REQUEST FOR INFORMATION (RFI)

PROJECT :	BKK2	R.F.I. NO. :	523213-01-RFI-AR-0025
TO :	CTA	ATTENTION :	CTA
SUBMITTED DATE:	19-Jan-26	NEED REPLY BY DATE :	26-Jan-26

SUBMISSION OF :	<input checked="" type="checkbox"/> Q&A	<input checked="" type="checkbox"/> Drawing	<input type="checkbox"/> Document	<input type="checkbox"/> Others (as specified below)
SUBJECT : Request for Information - Confirm for the Final Height of HMI Display from Fan Wall unit (FWU) with Respects to Human Ratio.

DRAWING NUMBER	523213 - 02 - DRG - AR-3316

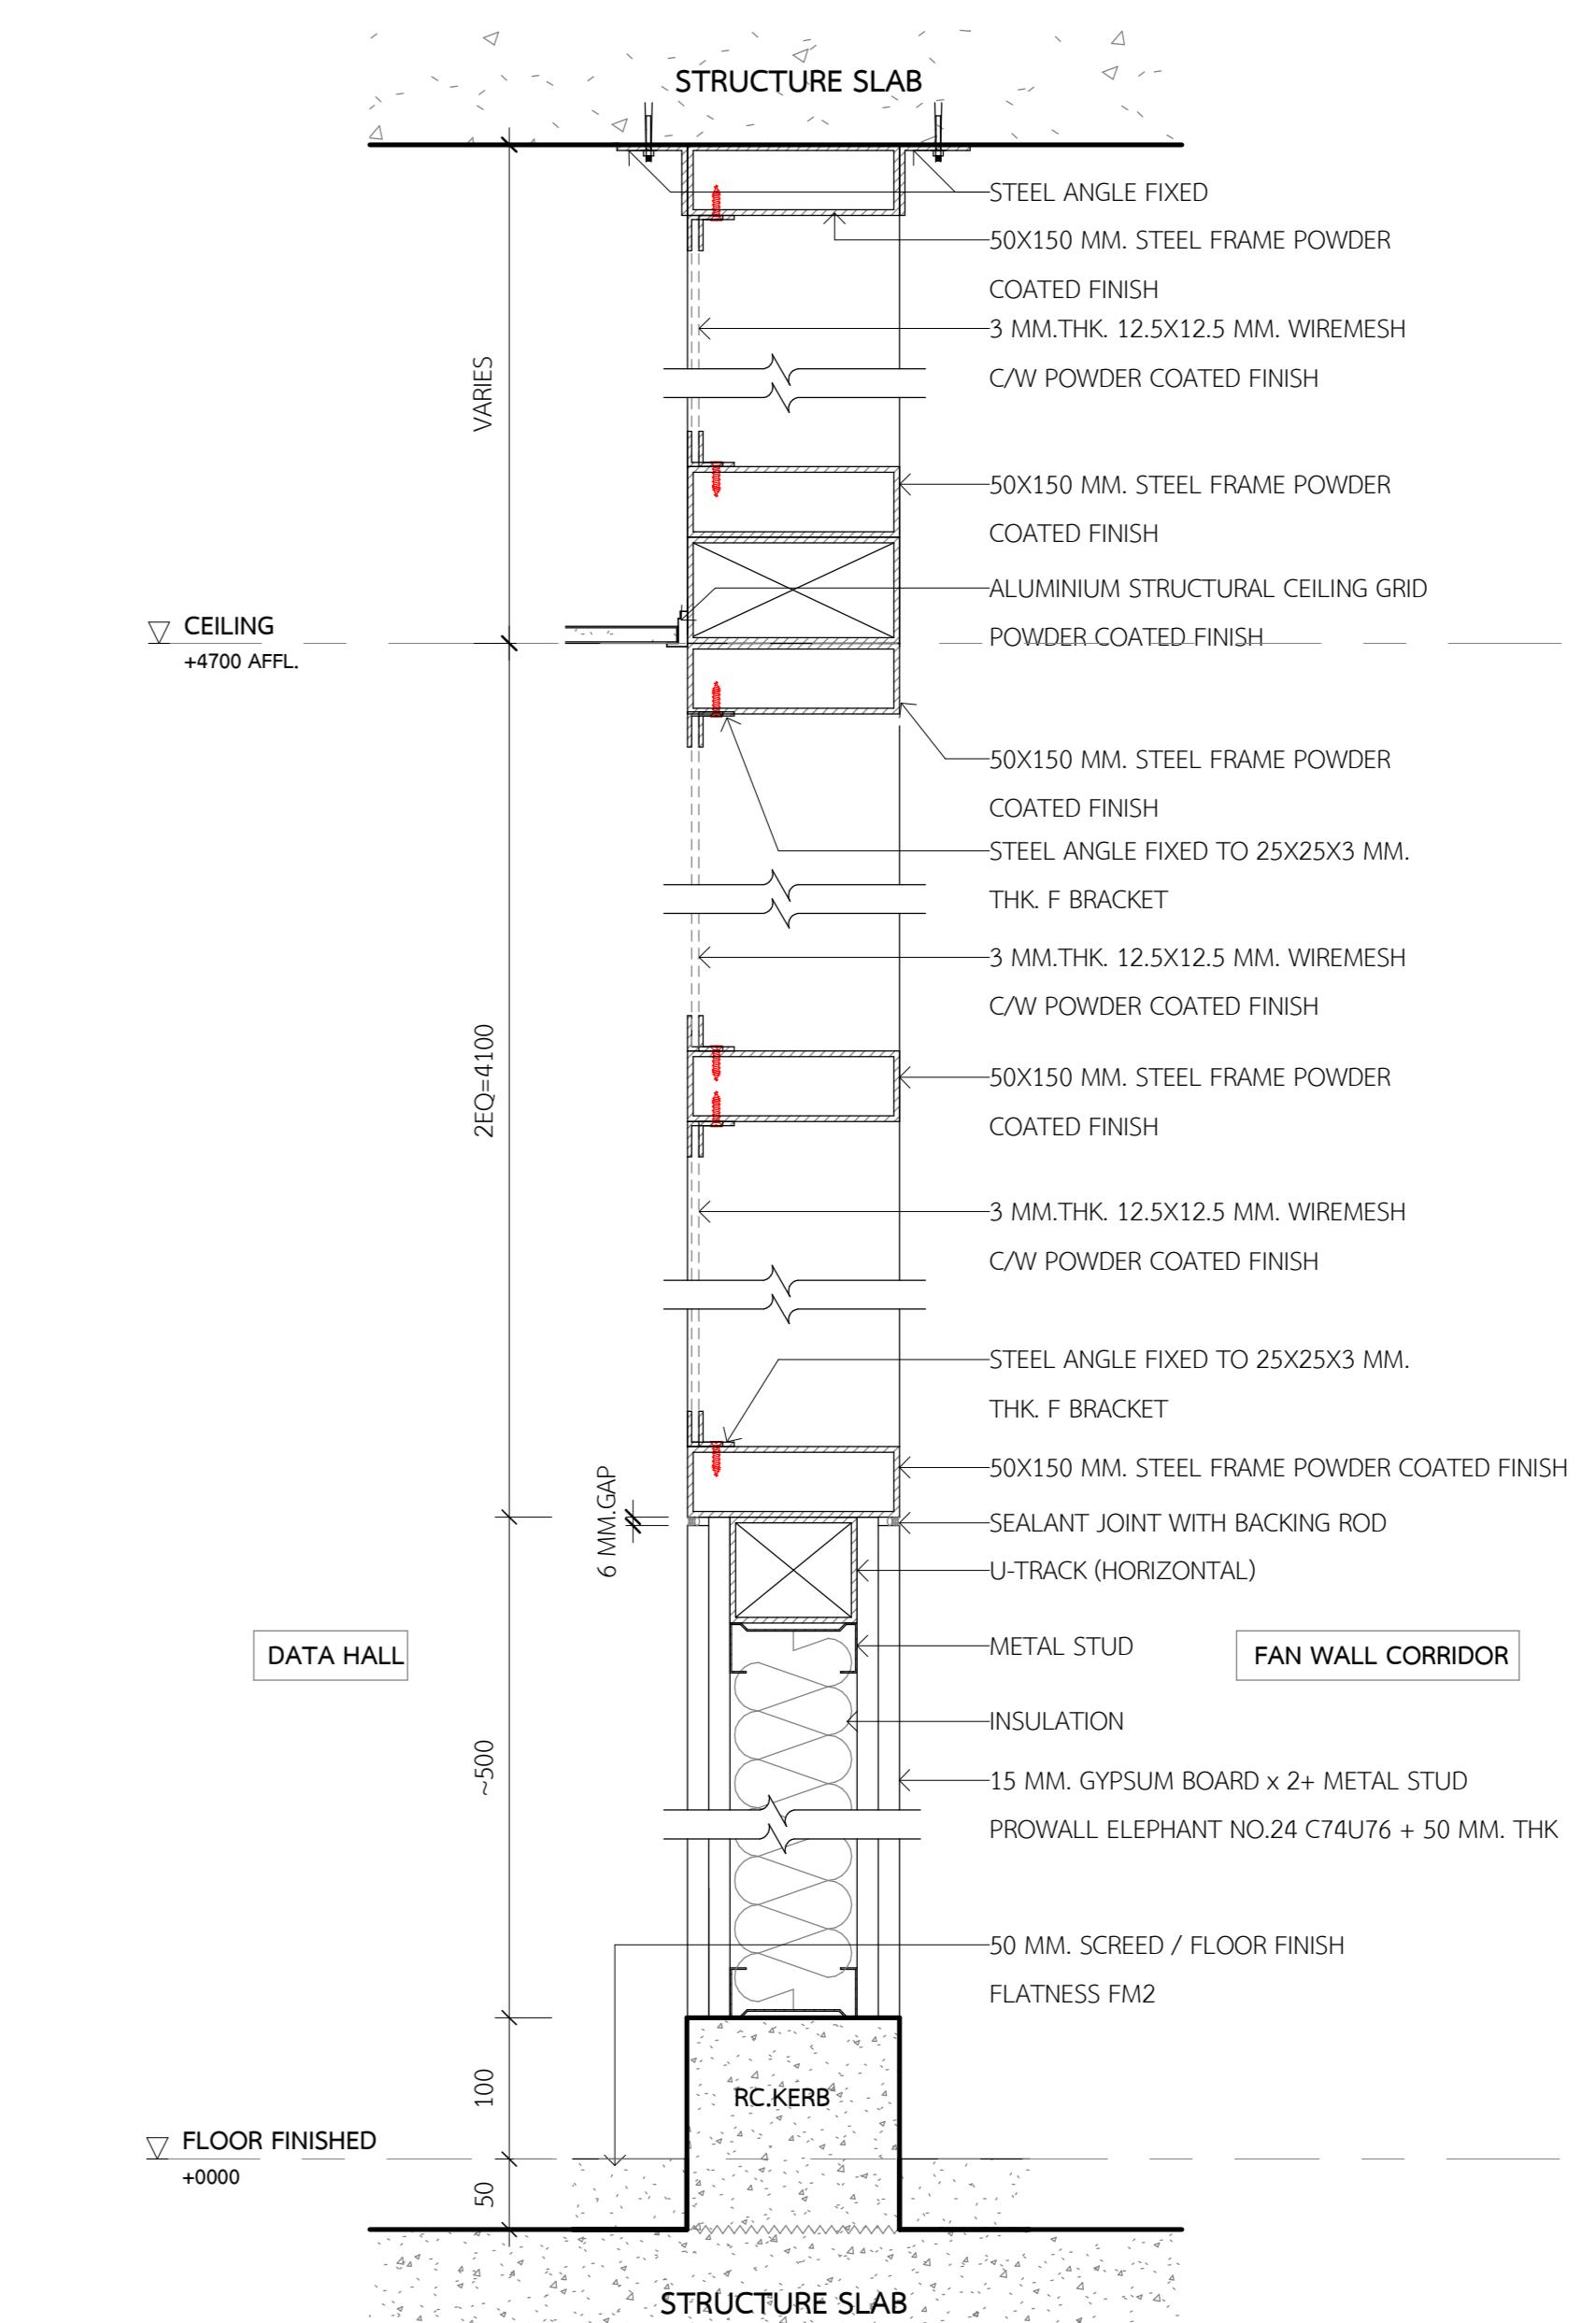
SLA: Please refer to the notes in the attached markup.

The height from consultant's response is for guideline. However, the location of HMI relates
to service and maintenance issue. Contractor shall come back with more propose section view
to demonstrate when operator stand on ladder step.
